Planning Officer's Addendum Report - LDCA JANURY 2026

APPLICATION	2025/86 – Installation of Security Fencing and Crash Barrier around the Rupert's Waste-Water Treatment Plant
PERMISSION SOUGHT	Full Permission
REGISTERED	30 September 2025
APPLICANT	Connect Ltd.
PARCEL	RV0075
LOCALITY	Rupert's Valley
ZONE	Coastal
CONSERVATION AREA	None
CURRENT USE	Waste Water Treatment Plant
PUBLICITY	<p>The application was advertised as follows:</p> <ul style="list-style-type: none">▪ <i>The Sentinel</i> Newspaper on 9 October 2025.▪ A site notice displayed in accordance with Regulations.
EXPIRY	23 October 2025
REPRESENTATIONS	None
DECISION ROUTE	Delegated / LDCA / EXCO

Diagram 2 – Proposed Plan (original submission)

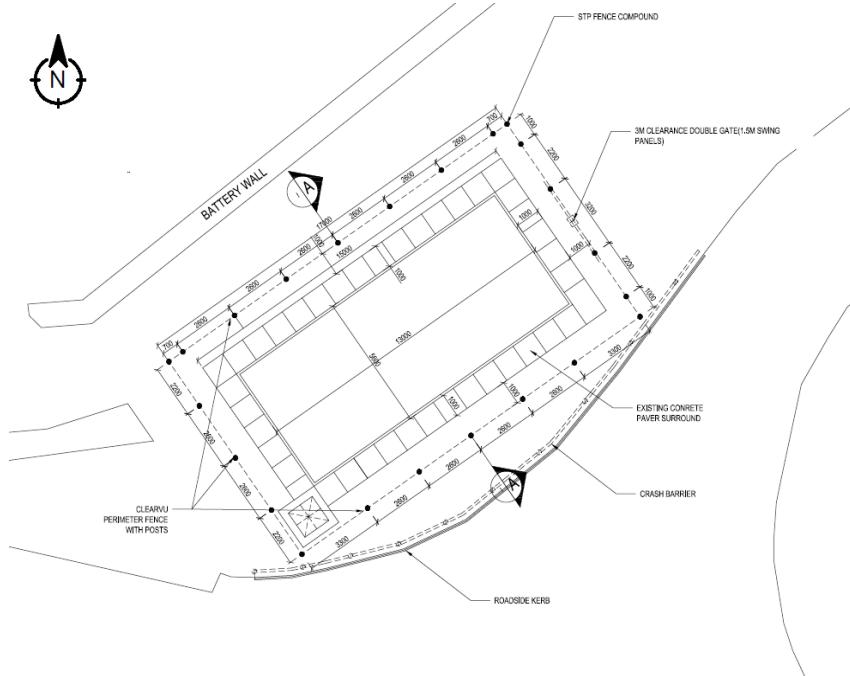
On 17th December 2025, the applicants wrote to advise that they could provide "the 1.7m as opposed to the initially proposed 2.6m fence (approximated to 3m in the conversations). This is approximately 2m high which is a desired height."

This current proposal is for galvanised 2m high steel fence posts and mesh panels and a crash barrier to the south of the waste-water plant with galvanised steel supports. Also shown is a concrete paviour surround which was not approved in relation to the previous plans.

Revised plans are to be provided in advance of the January LDCA Meeting but at the time of drafting this addendum (19.12.25) are not available; it is expected they will be provided in time to be included in the presentation, and, as appropriate, in Condition 2. The remainder of the previous report is provided below, amended to include the change proposed to the height of the fencing to 2m.

Diagram 3: Elevations of Proposed Security Fence (Original submission)

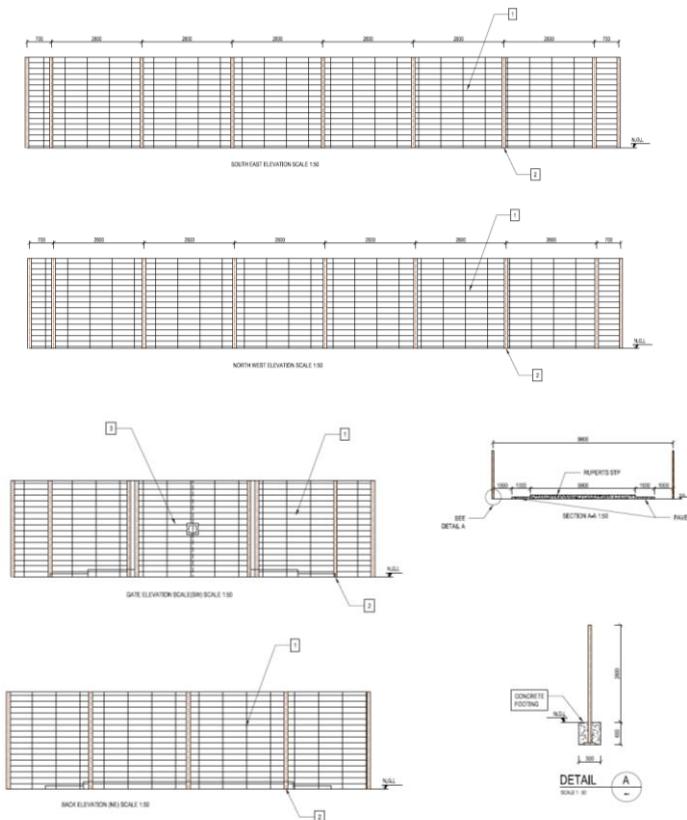
At the LDCA Meeting on 4th December 2025, Members deferred the Development Application requesting that, due to the close proximity of the proposed fence to the listed monument, Rupert's Lines, that the fencing/posts be reduced in height from the proposed 3m.
